Deicorp Projects Showground
Pty Ltd

Doran Drive Precinct, Doran
Drive, Castle Hill NSW

**DA Access Review
Final**

22 April 2022

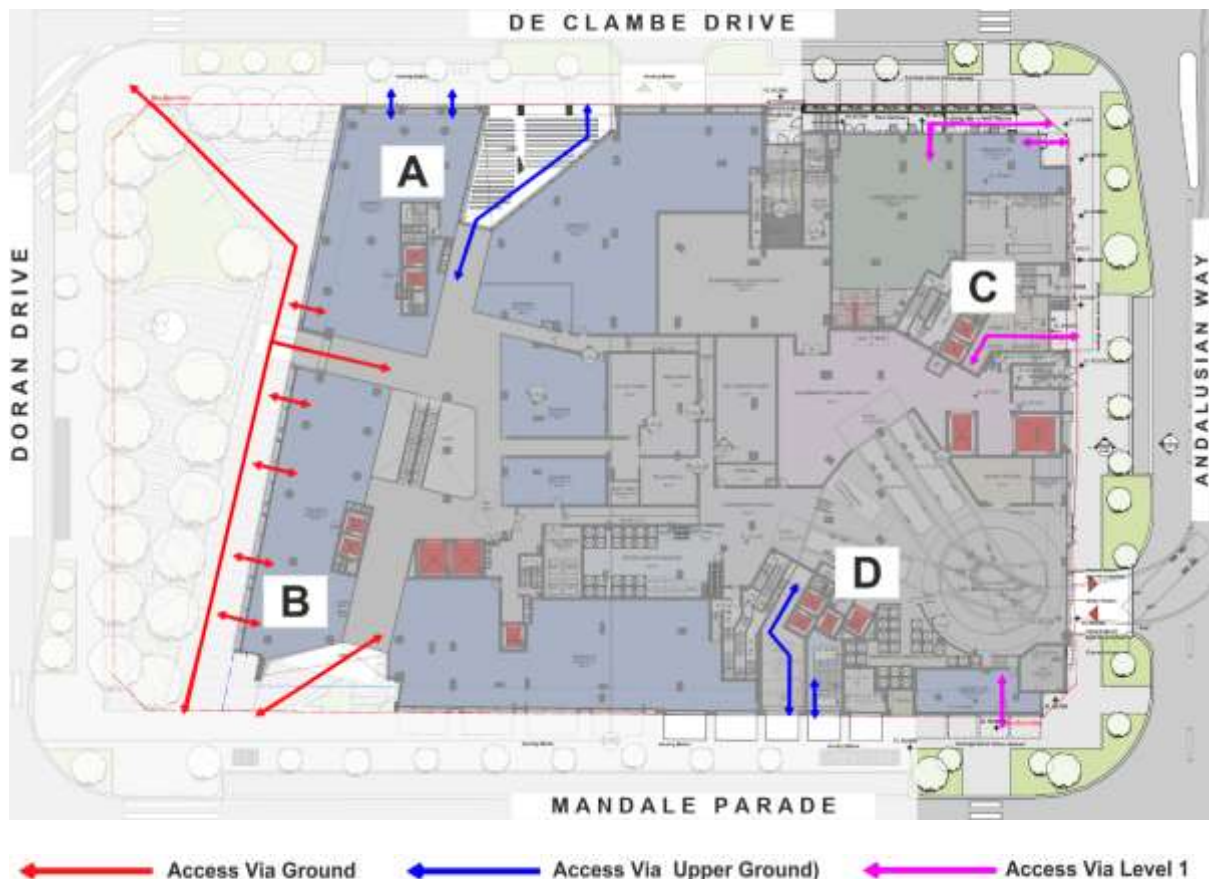
MGAC has reviewed the drawings and documentation in relation to the aforementioned requirements. The following diagram shows proposed access from the allotment boundary to the four residential tower and retail tenancies.

On the basis of the current level of detail all access requirements appear capable of achieving compliance subject to the resolution of some minor issues with regards to the continuous accessible path of travel (CAPT) from the allotment boundary at corner of Clambe Drive and Doran Drive to the principal pedestrian entrance (PPE) and 600mm drop level from Doran Drive to the shopping centre principal pedestrian entrance. There is sufficient space for amendments to be made to readily achieve compliance during a further stage.

The proposed design is capable of achieving compliance, subject to details noted in the above. It is understood this will be refined during the design development stage and prior to Construction Certification (CC).

Figure 2. L2 - Access Points from Lift Lobbies to Residential Podium

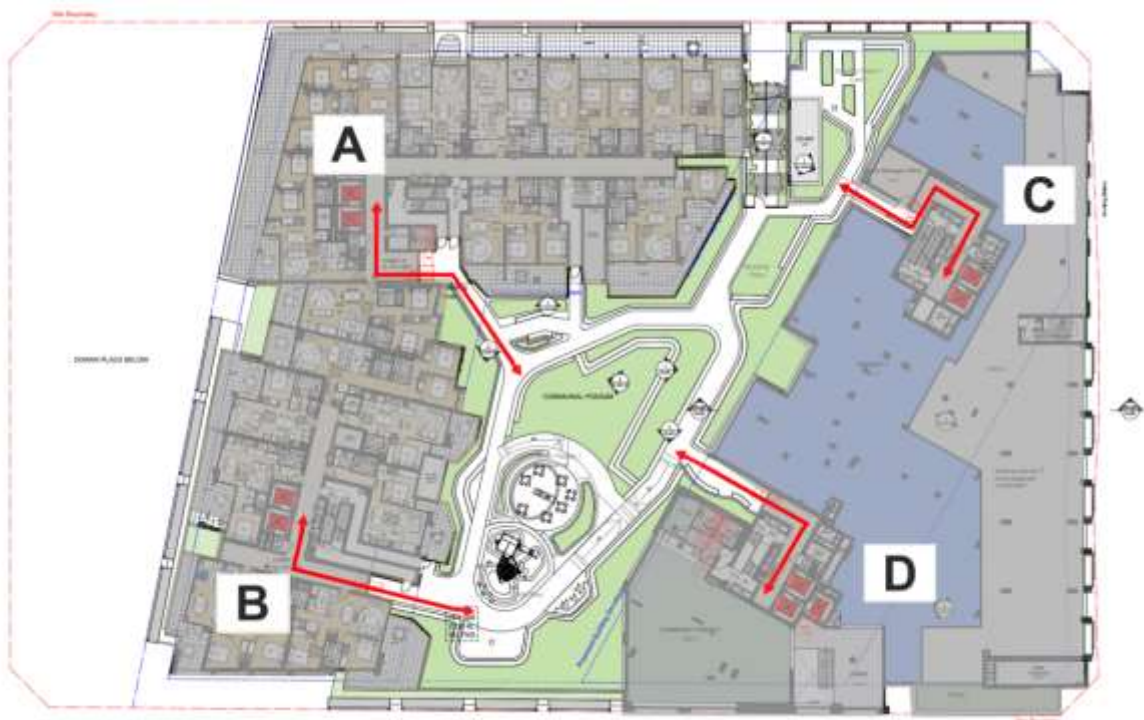
MGAC has reviewed the drawings and documentation in relation to the aforementioned requirements. The following diagram shows proposed access from proposed lift lobbies residential communal podium via each lobby of towers A, B, C & D at level 2.

Design team is to ensure that the continuous accessible path of travel (inside/outdoor) is compliant with AS1428.1 Clause 6 and 7. Pathways link intersections are to provide compliance with AS1428.1 Figure 4.

On the basis of the current level of detail all access requirements appear capable of achieving compliance subject to the resolution of some minor issues with regards to tenancy 8 proposed in the block A facing Doran Drive (ground floor) provides connection to the upper level via stairs only.

Design is to consider the continuous accessible path of travel (CAPT) journey to be made by a wheelchair user from the inside of the tenancy at the ground floor to the upper level. Provide lift access or MGAC is to support compliance under a Performance Based Solution, by a management plan. This is to include an agreement with building owner to ensure that tenants are provided the same experience equally on both levels. Agreement is to be recorded in the tenancy agreement by-laws. This requirement can be addressed during detail design stage. Note: The Performance Based Solution via a management plan will be subject to the provision of a statement from the stake-holder outlining the reasons why compliance has not been achieved
